# County of Fairfax, Virginia

Subject: Woodside Estates, Section 3, Lot 16A; 8747 Brook Road; Dranesville District;  
Tax Map No: 020-3-03-0016A

Reference: Water Quality Impact Assessment # 3276-WQ-003-1

WATER QUALITY IMPACT ASSESSMENT 118-2-1(D)(3)  
8747 BROOK ROAD  
FAIRFAX COUNTY, VIRGINIA

**WATER QUALITY IMPACT ASSESSMENT MAP**

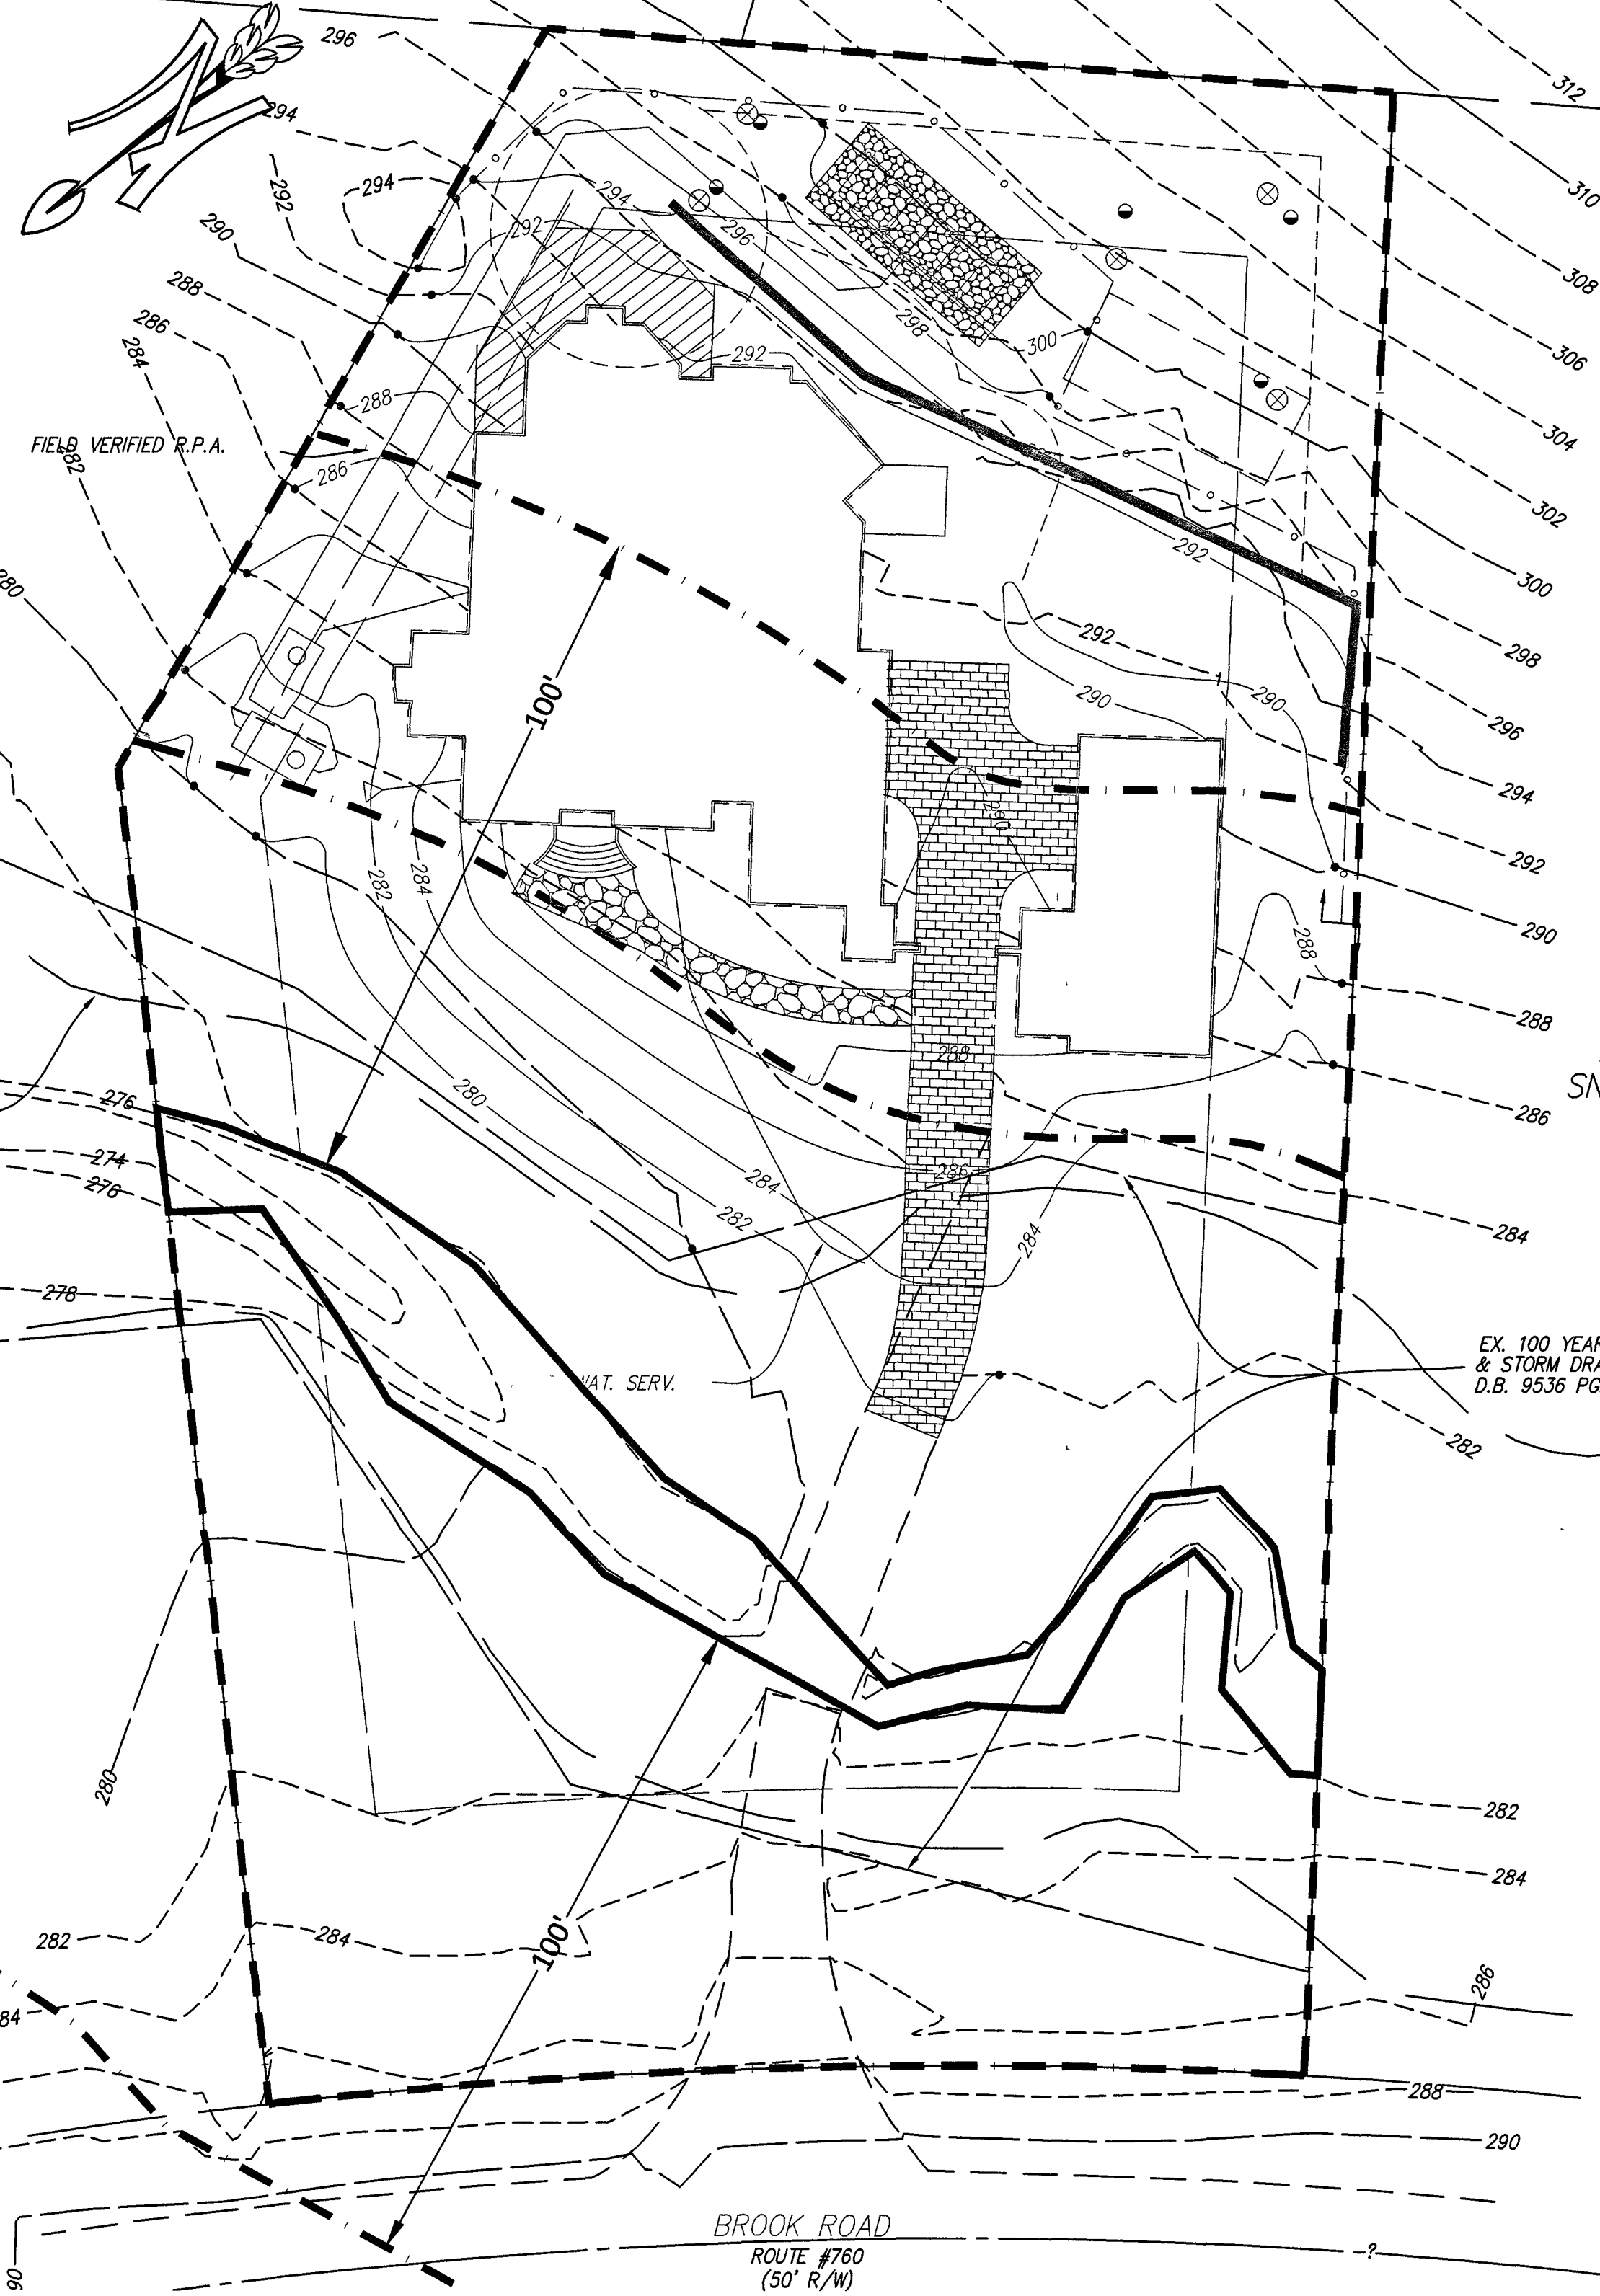
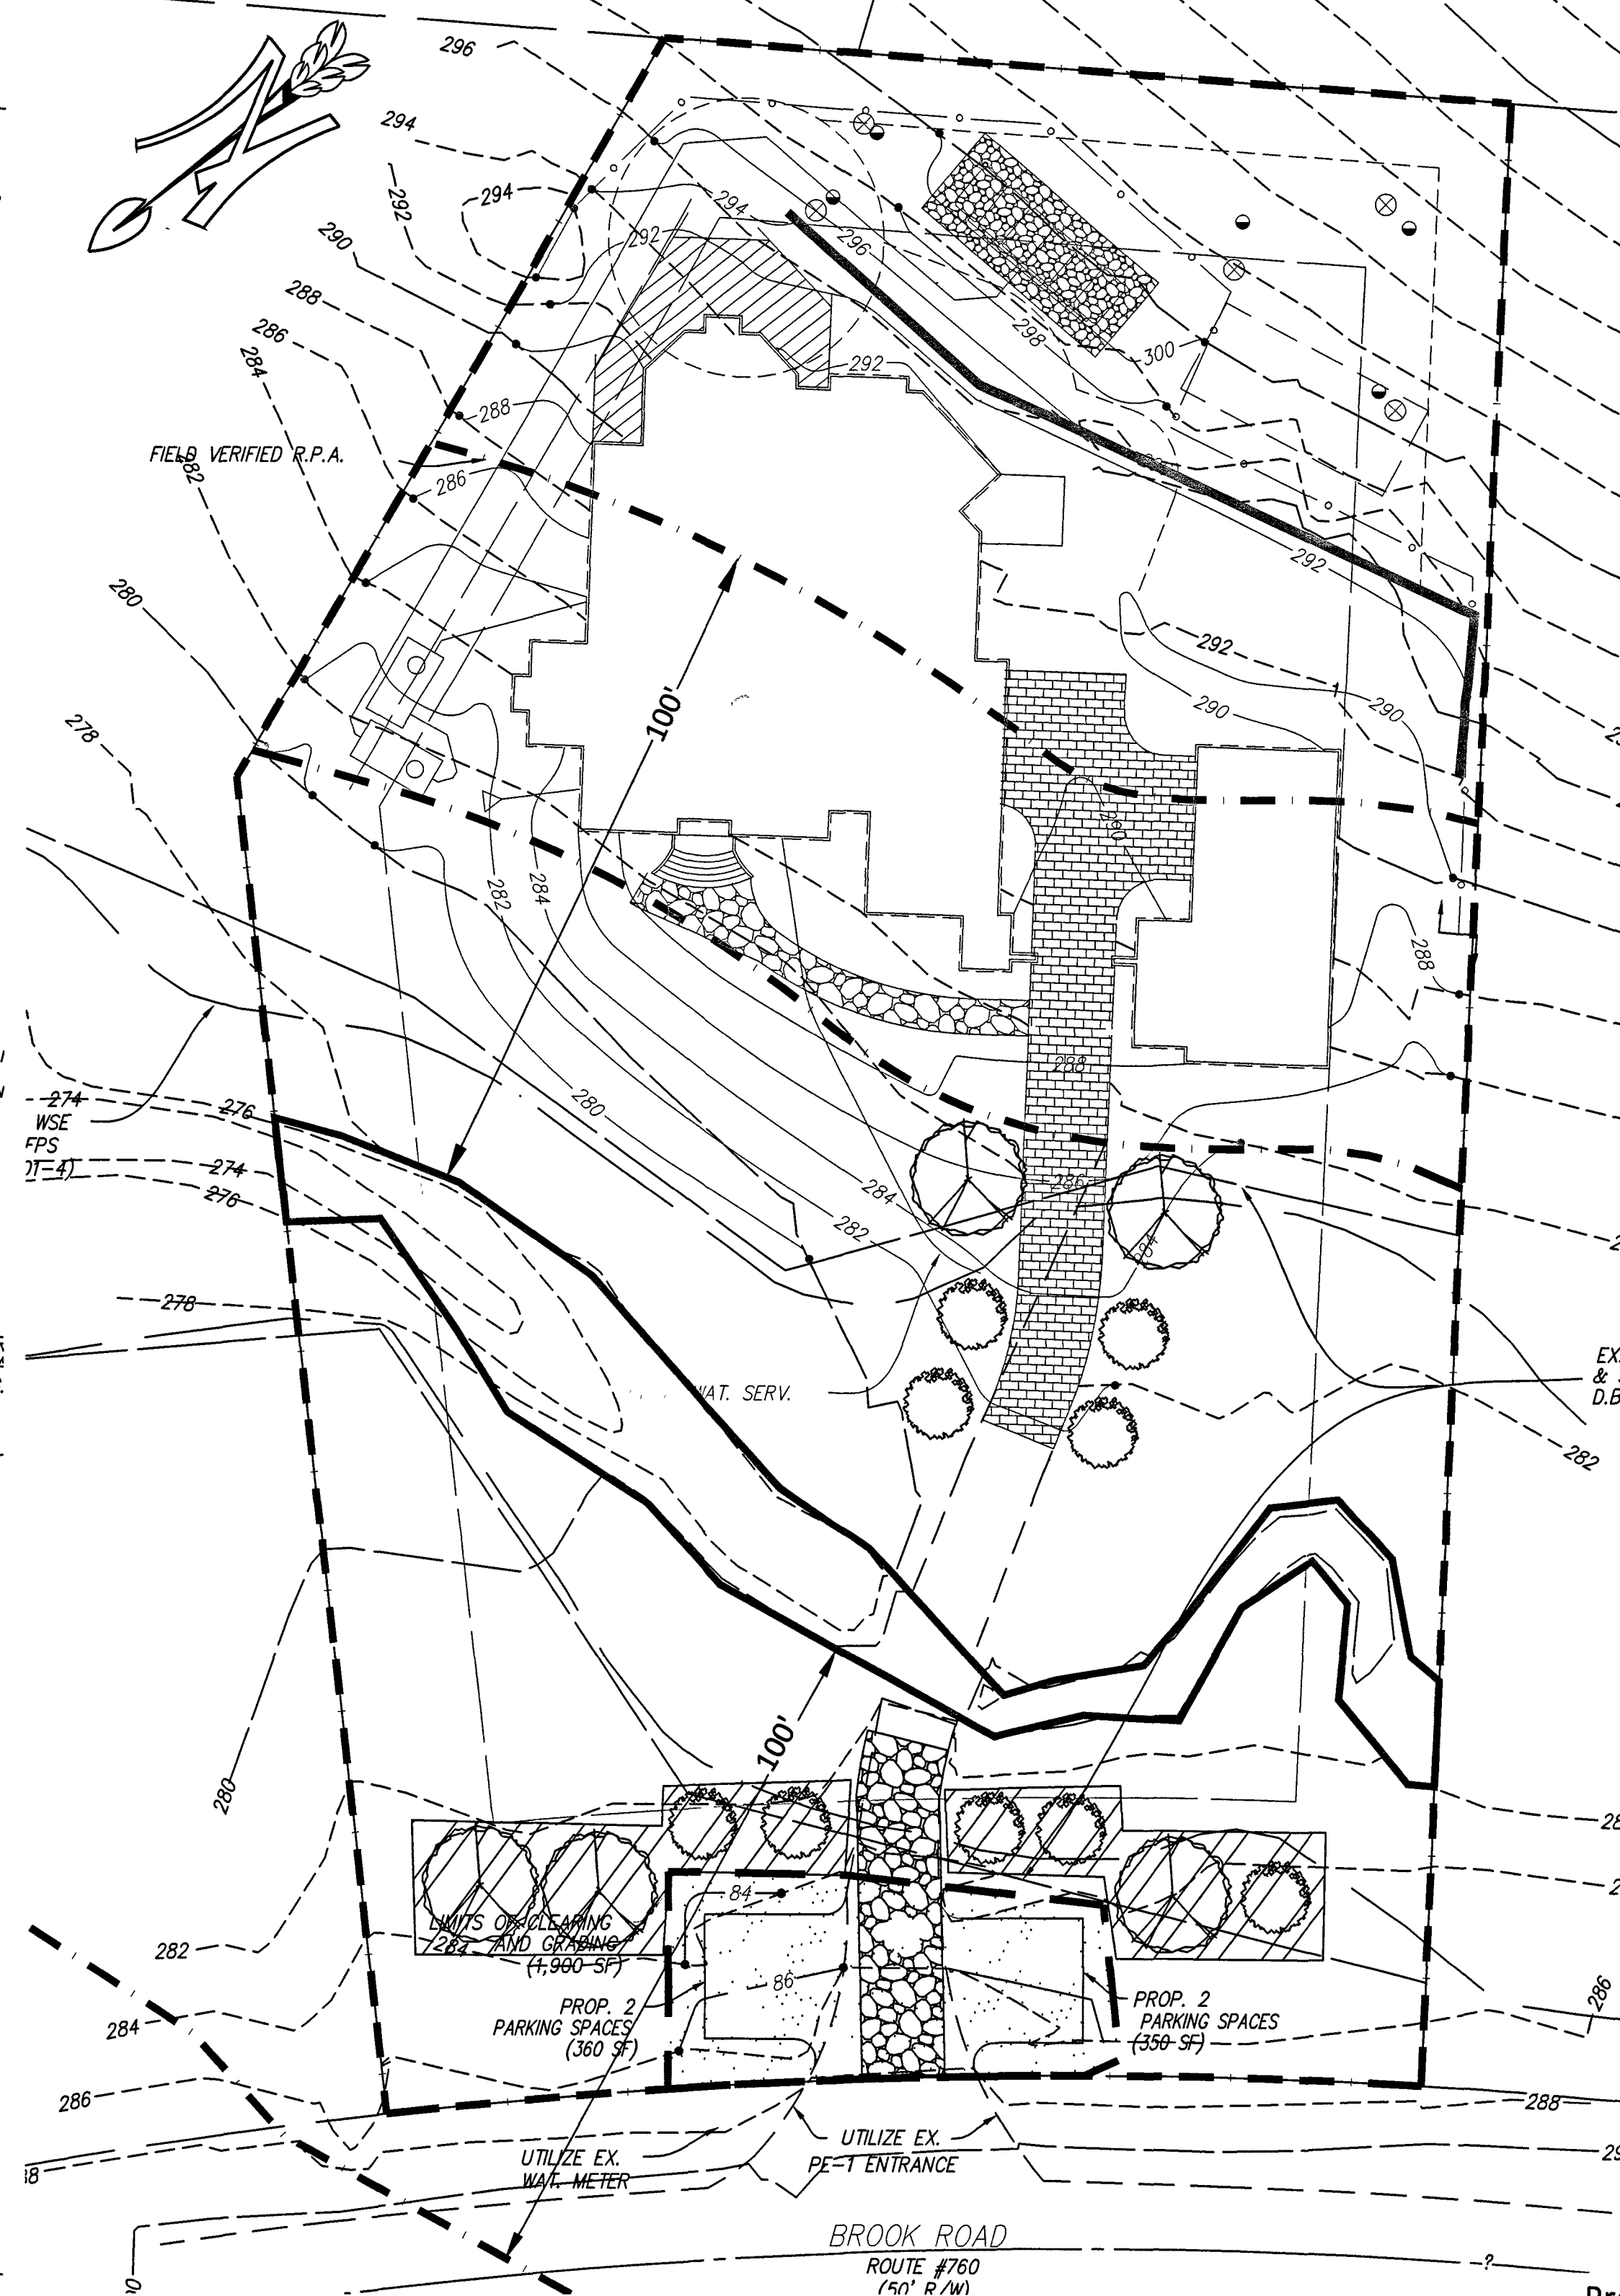
Your request to construct parking spaces at the entrance to the driveway cannot be approved administratively. On October 3, 2012, an exception was approved for the subject lot by the Chesapeake Bay Preservation Ordinance (CBPO) Exception Review Committee (ERC): Resource Protection Area Exception # 3276-WRPA-002-1 and Water Quality Impact Assessment # 3276-WQ-002-1. To further your current request, please submit it under CBPO Section 118-6-9. Exceptions reviewed by the CBPO ERC require a public hearing.
